Job	Truss	Truss Type	Qty	Ply	LOT 0.0092 BLAKE POND 122 WHIMBREL COURT LILLINGTON, NC
24-1221-R01	R04RP2	Common	7	1	Job Reference (optional)

REPAIR(S) REQUIRED

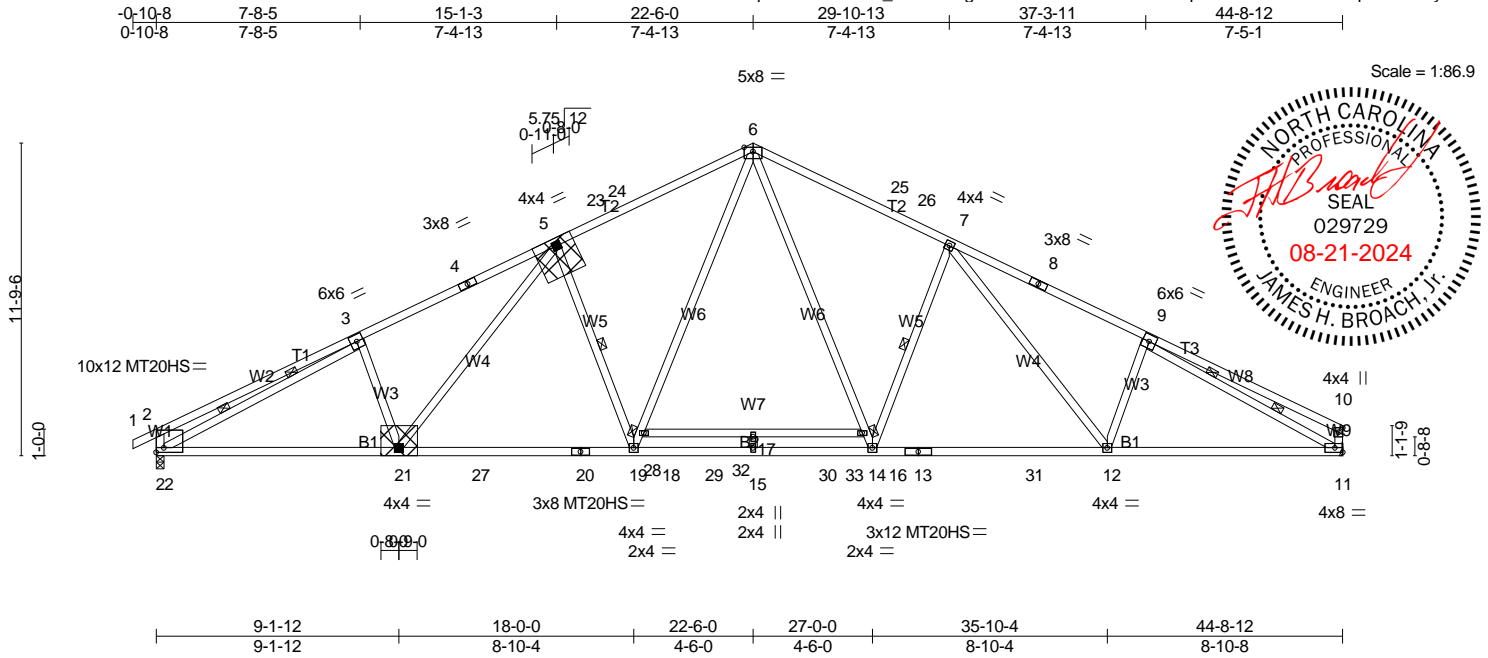
- Repair Condition: Missing diagonal web 5-21 with damaged plate(s) on both side(s) of truss at joint(s) 21,5.
- Attach 14"H X 17"W X 7/16" OSB (APA Rated Sheathing 24/16 Exposure 1) gusset to both sides of truss at joint 21 with 10d (0.131"x3") nails from each face, driven through both sheets of plywood and clinched. Connected together as follows: 2x4 - 2 rows 0-6-0 o.c. Minimum 0-3-0 end distance.

- Attach 18"H X 19"W X 7/16" OSB (APA Rated Sheathing 24/16 Exposure 1) gusset to both sides of truss at joint 5 with 10d (0.131"x3") nails from each face, driven through both sheets of plywood and clinched. Connected together as follows: 2x4 - 2 rows 0-6-0 o.c. Minimum 0-3-0 end distance.

- Remove any remaining fragments of missing diagonal 5-21 and repalce with same size and grade material cut to fit tight.
- Unbalanced roof live loads have been considered for this design.
